6338 Hudson Crossing Pkwy

Site Plan Application

Hudson Planning Commission	SITE PLAN REVIEW
Case No. 2019-550 January 11, 2020	July 2, 2019

Approve the site plan in Case 2019-550 for 6336 Hudson Crossing Parkway, Parcel #3010245, Hudson Business Park according to plans received June 21, 2019 subject to the following conditions:

CEIA USA
HUDSON CROSSING PARKWAY
HUDSON CROSSING BUSINESS PARK
HUDSON, OHIO
SITE PLAN

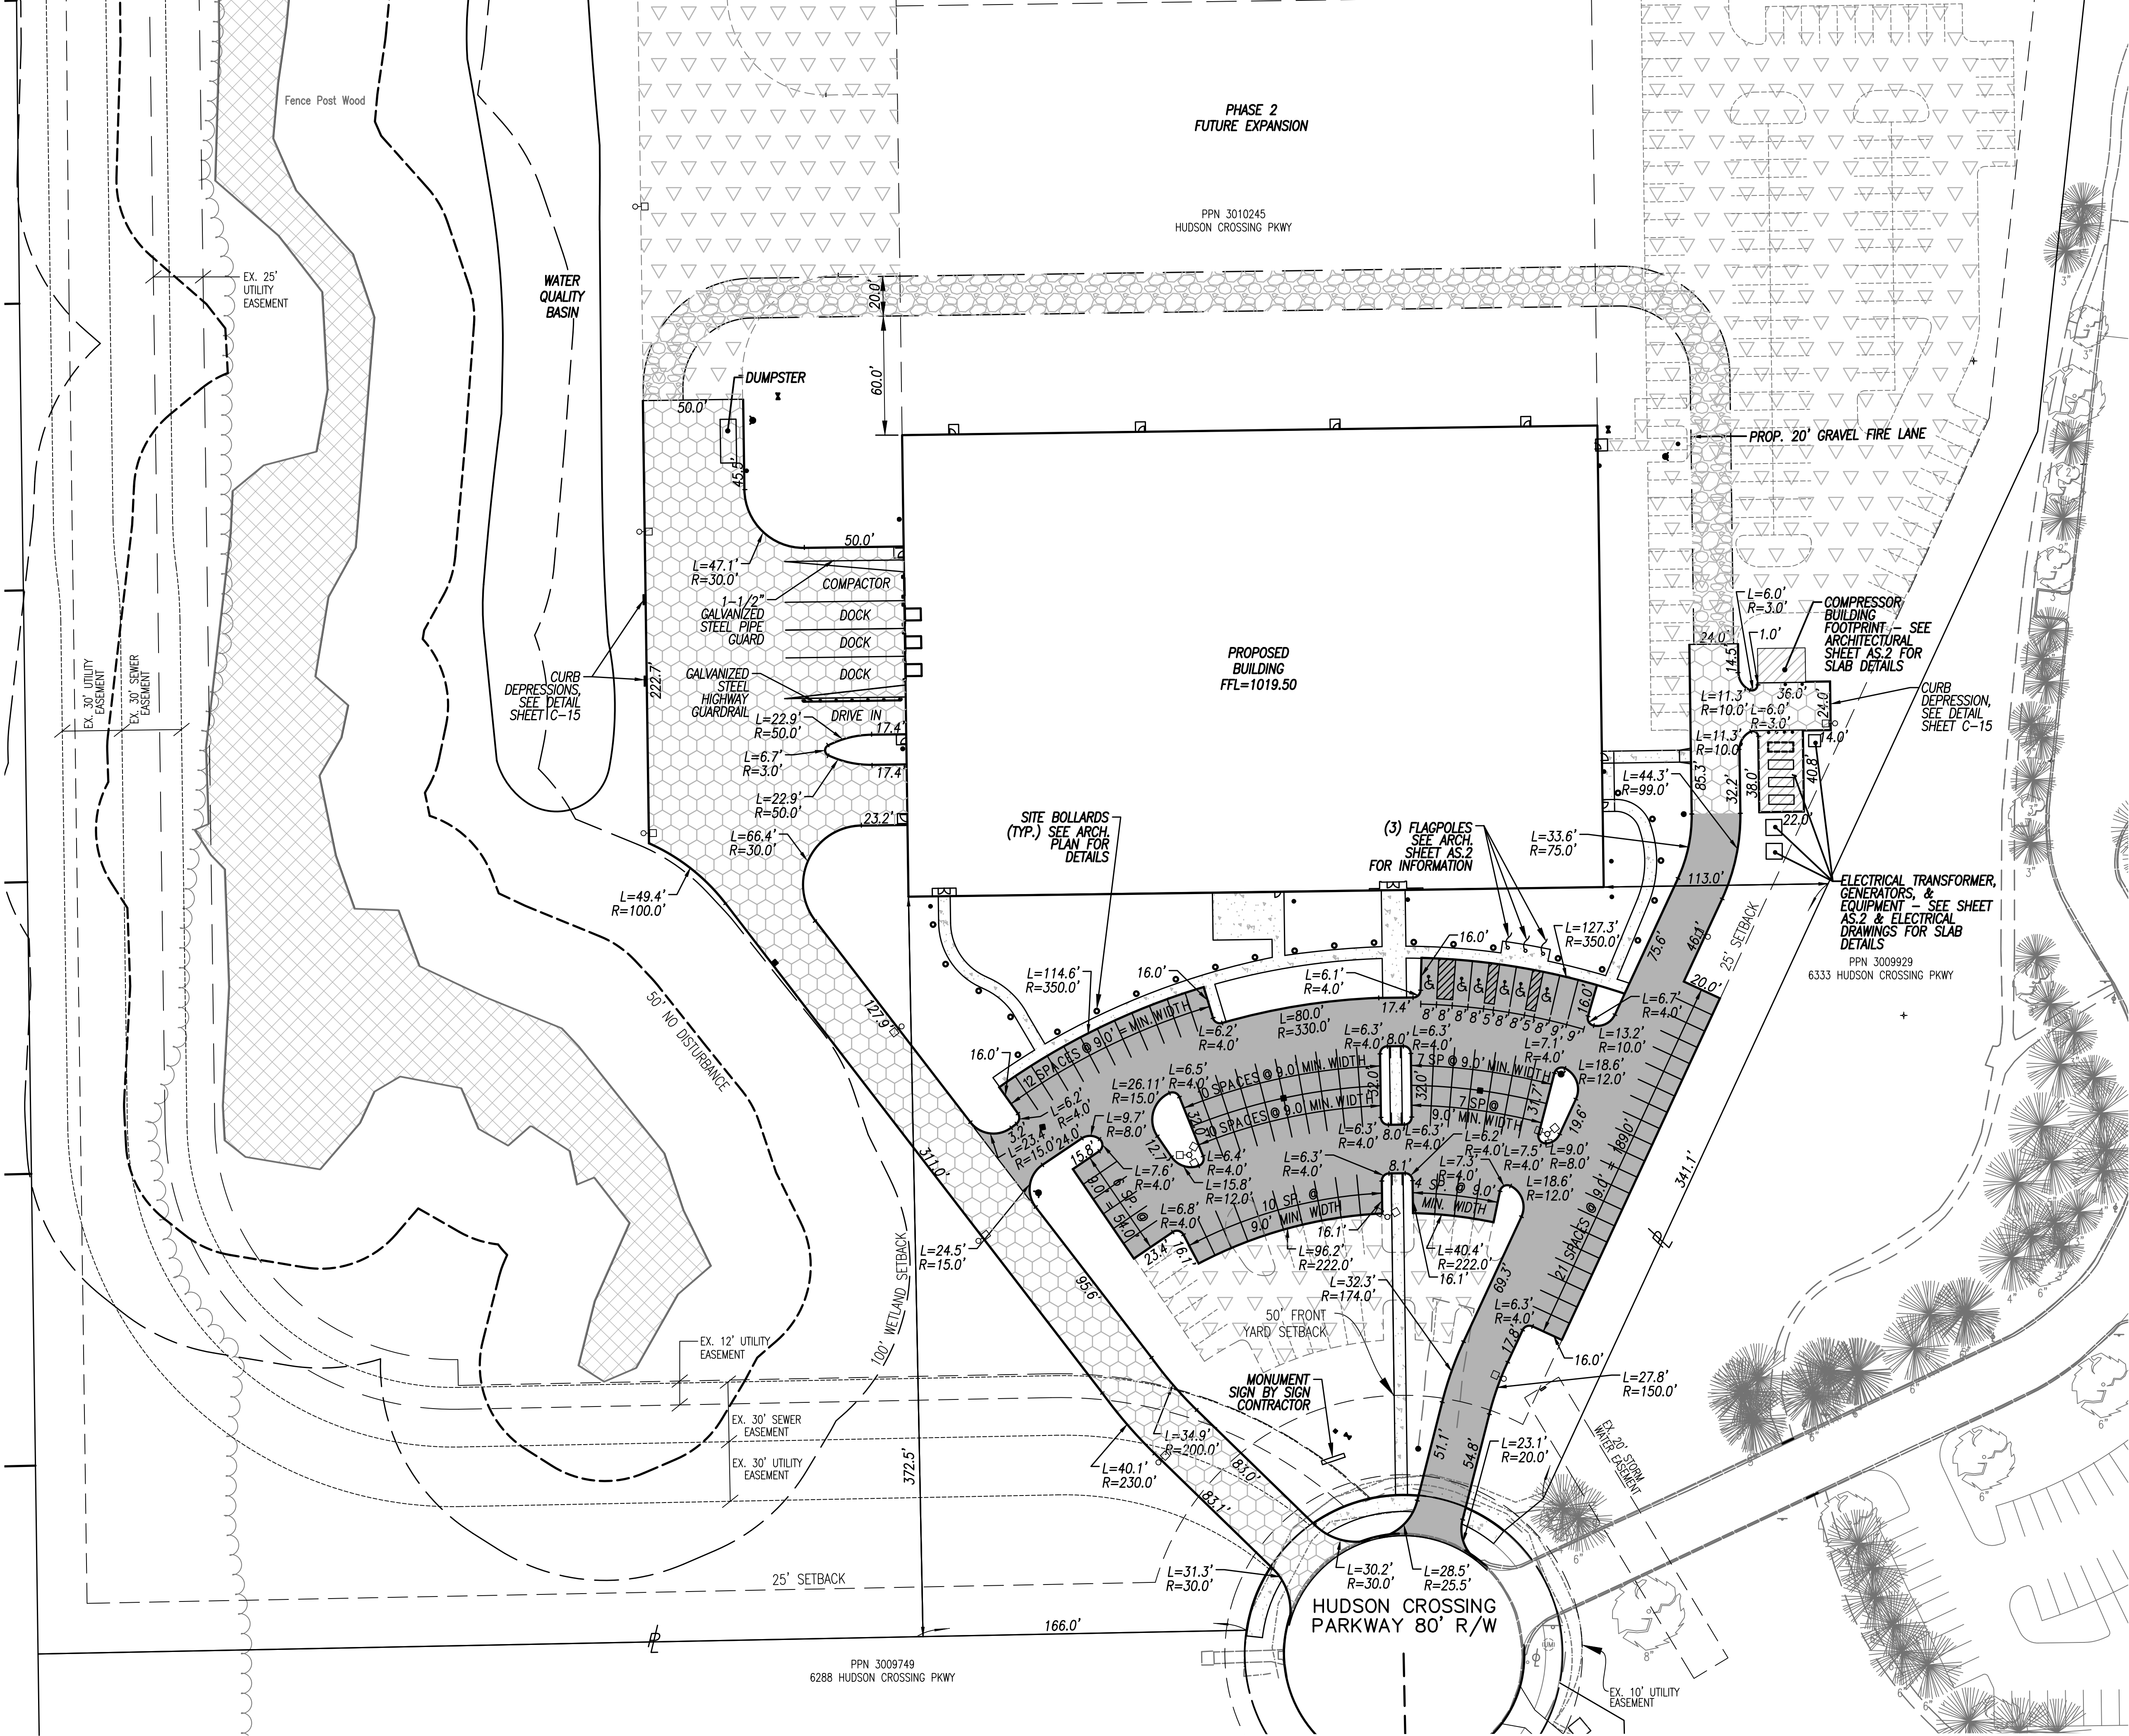
- ☐ **Circulation** The site plan should minimize the number of curb cuts (reduce to one curb cut from two) to provide for safe and functional movement of traffic onto, off of, and within the site per Section 1207.18(f)(1)(A). (Condition 3)

7. A long-term maintenance plan (LTMA) will be required for this site. The City has a template LTMA form available.
8. Are two separate drive entrances required? Can one entrance be utilized? The driveway locations with the adjacent properties shall be reviewed and any signage needed, shall be included in the final submittal.

1. Submission of updated wetland delineation report and flood zones is required.
2. Planning Commission accepts the minor changes to the elevations from the approved recommendation of the Design Subcommittee on July 8, 2018 for Development in Districts 6 and 8 and approves the project design.
3. Spec sheets on lighting fixture types.
4. Reduce the number of curb cuts to one.
5. The comments of City Engineer, Brad Kosco must be addressed per the June 28, 2019 correspondence for final approval of the plan.
6. Subject to review and approval by Fire Marshal, Shawn Kasson.
7. Satisfaction of the above conditions prior to scheduling of a preconstruction meeting with City Officials and no clearing or construction of any kind shall commence prior to the issuance of a Zoning Certificate.
